KU-RING-GAI LOCAL PLANNING PANEL MEETING TO BE HELD ON MONDAY, 17 NOVEMBER 2025 AT 11:00 AM BY ZOOM CONFERENCING

21 Mahratta Avenue Wahroonga - Alterations and Additions to the Existing Principal Dwelling House

GB.2 1 Russell Avenue, Lindfield - Demolition of existing structures and construction of a residential flat building with basement carparking and associated works

REPORT TITLE:	21 MAHRATTA AVENUE WAHROONGA - ALTERATIONS AND ADDITIONS TO THE EXISTING PRINCIPAL DWELLING HOUSE
ITEM/AGENDA NO:	GB.1

Figure 1: Conflict between accessible parking space and manoeuvring

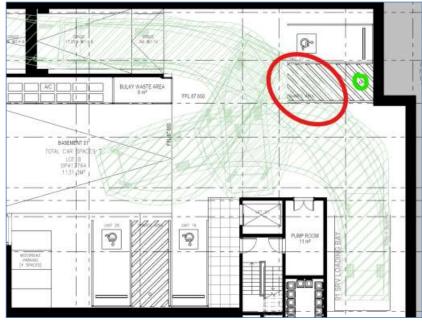
- c) The vehicle clearance assessment for the driveway adopts an incorrect B85 vehicle clearance of 159 millimetres. The requirements outlined in AS2890.1 require the assessment based on 120 millimetres vehicle ground clearance.
- d) The driveway clearance has not been assessed for the B99 vehicle in accordance with the requirements outlined in AS2890.1.
- e) The proposal includes a dedicated loading area in the Basement 01 level with a height clearance of 2.6 metres, designed to accommodate Council's waste collection vehicle, as well as smaller service and removalist vehicles. However, swept paths in the Transport Impact Assessment (TIA) indicate that a manoeuvring service vehicle would sweep over the shared zone of an accessible car parking space (Figure 1). Additionally, the location of the bollard is not compliant with AS2890.6.

Figure 1: Conflict between accessible parking space and manoeuvring

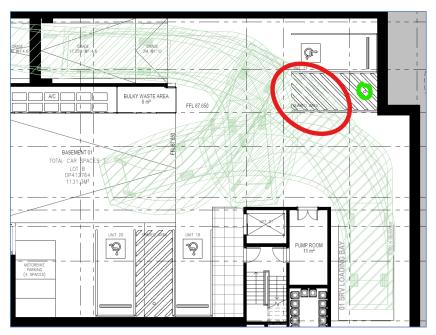
- d) The driveway clearance has not been assessed for the B99 vehicle in accordance with the requirements outlined in AS2890.1.
- e) The proposal includes a dedicated loading area in the Basement 01 level with a height clearance of 2.6 metres, designed to accommodate Council's waste collection vehicle, as well as smaller service and removalist vehicles. However, swept paths in the Transport Impact Assessment (TIA) indicate that a manoeuvring service vehicle would sweep over

the shared zone of an accessible car parking space (Figure 1). Additionally, the location of the bollard is not compliant with AS2890.6.

Figure 2: Proposed streetscape upgrade and pedestrian island

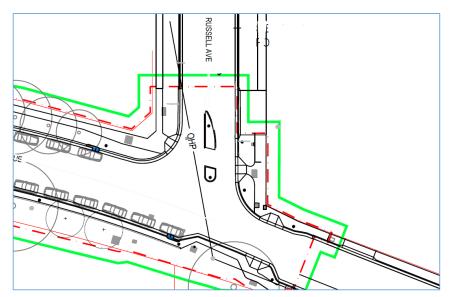
- g) The proposed driveway access point conflicts with Council's proposed streetscape upgrade of Lindfield Avenue and Tryon Road as a pedestrian refuge is proposed in Russell Avenue at the intersection with Lindfield Avenue (Figure 2). Widening the existing driveway crossing of No. 1 Russell Avenue towards Lindfield Avenue may result in vehicle and service vehicle access issues due to the presence of the proposed pedestrian refuge which will adversely impact on entry and exit movements. Updated swept paths of passenger vehicles and service vehicles need to be provided. If the conflict cannot be resolved, the access driveway would need to be relocated to the Lindfield Avenue frontage.
